E. Public Projects

Map E-2: Potential Public Viewsites

October 2014 EPC Red-Line

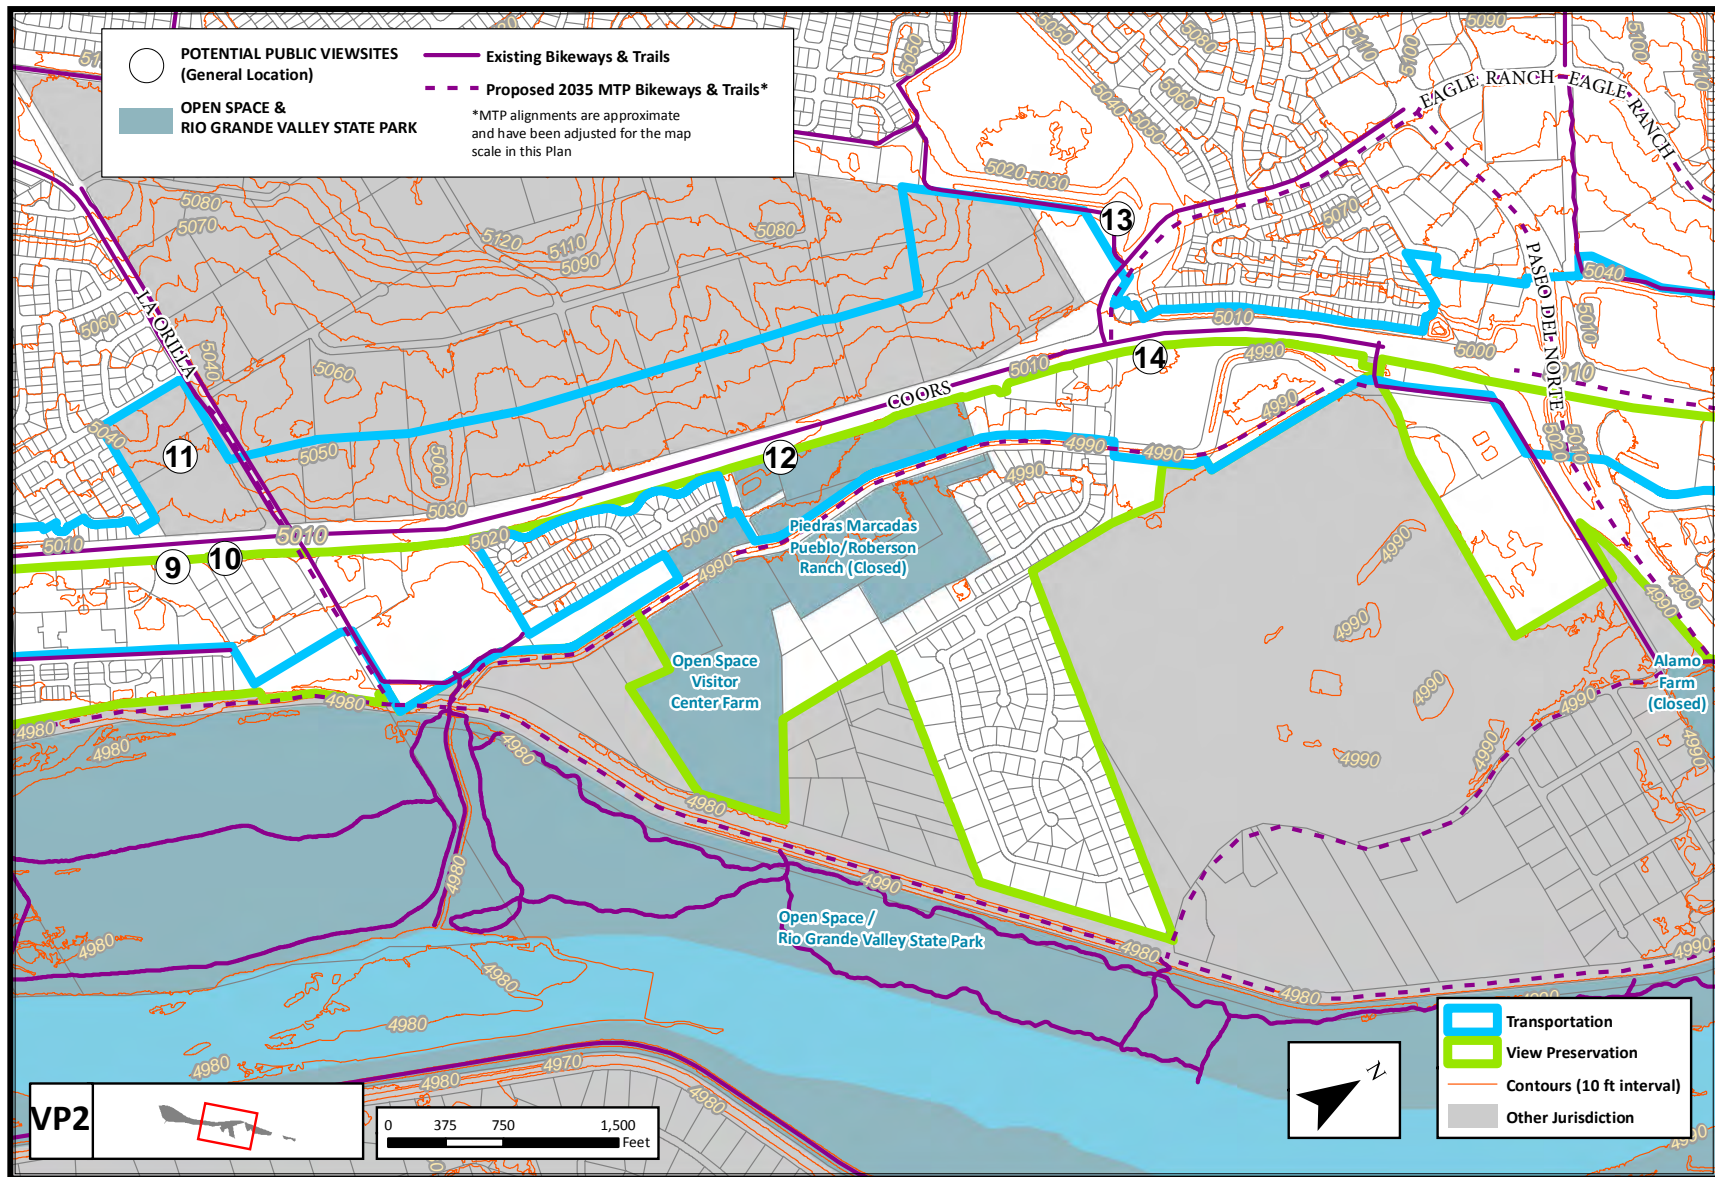
REVISED

Map E-3: Potential Public Viewsites

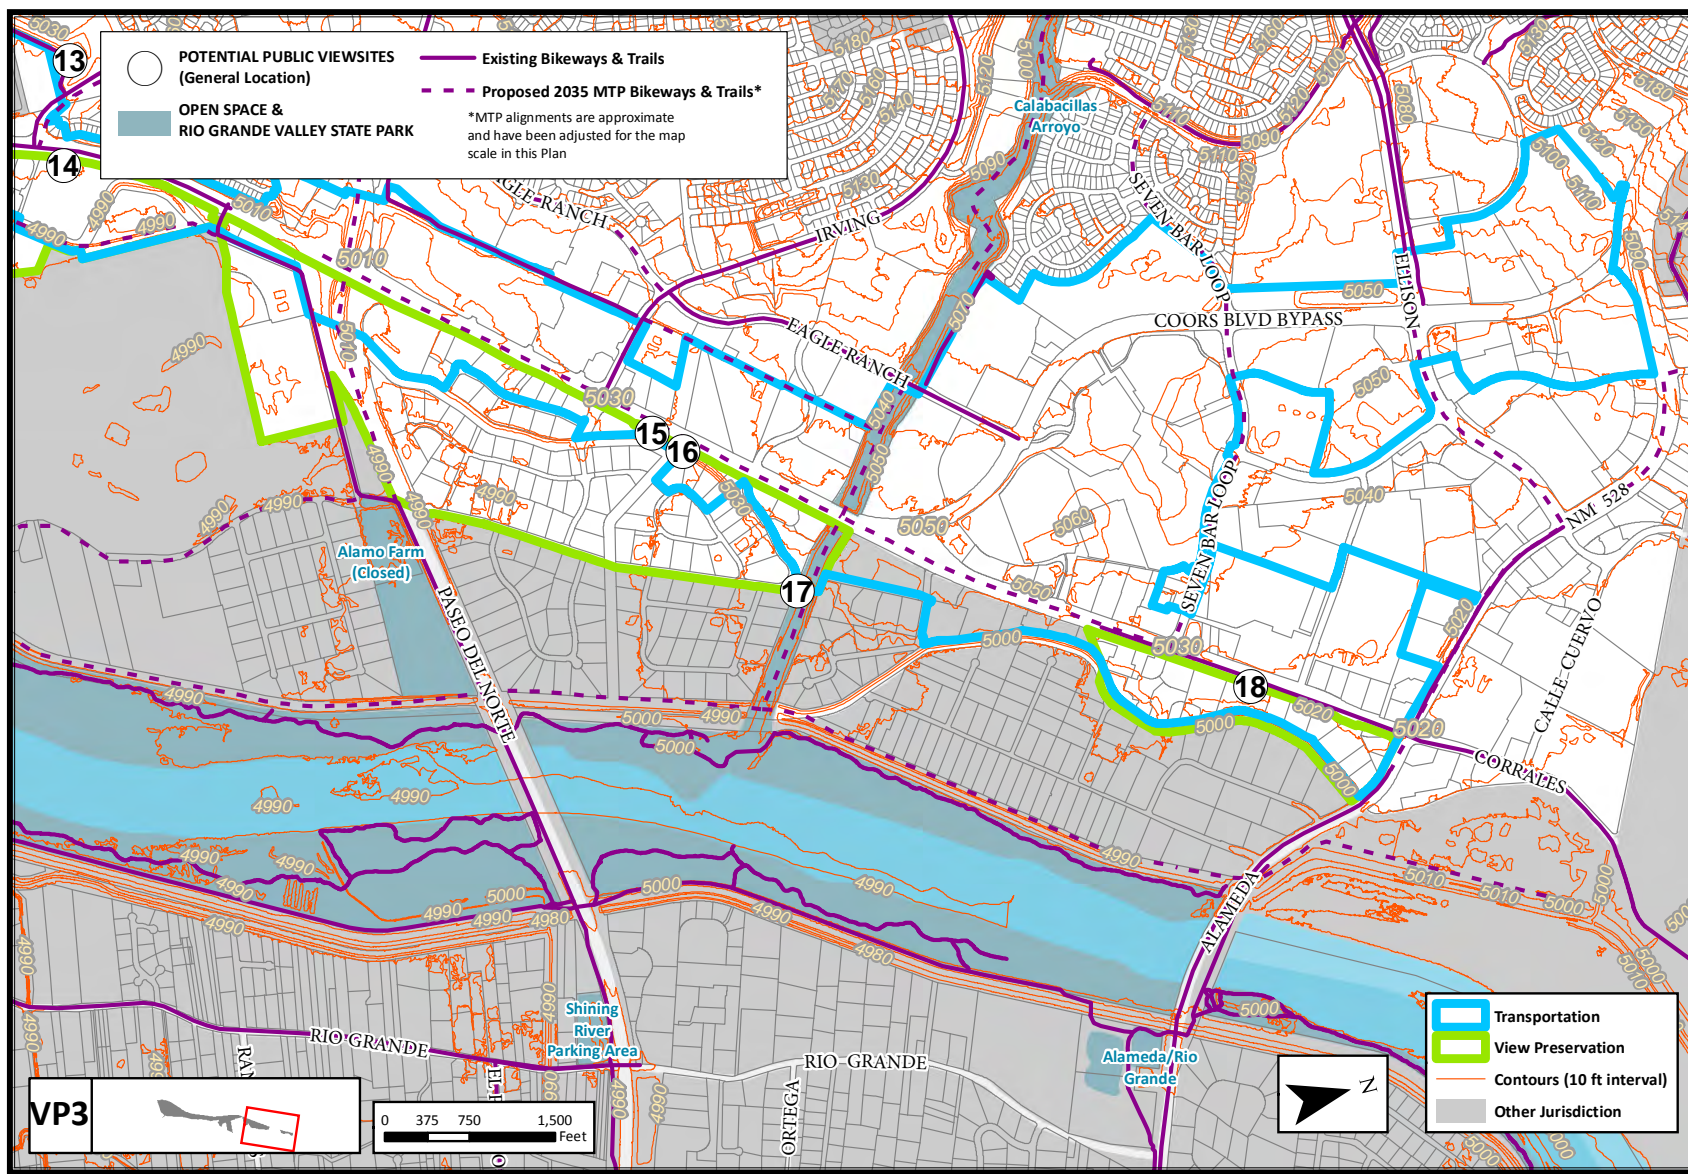
REVISED
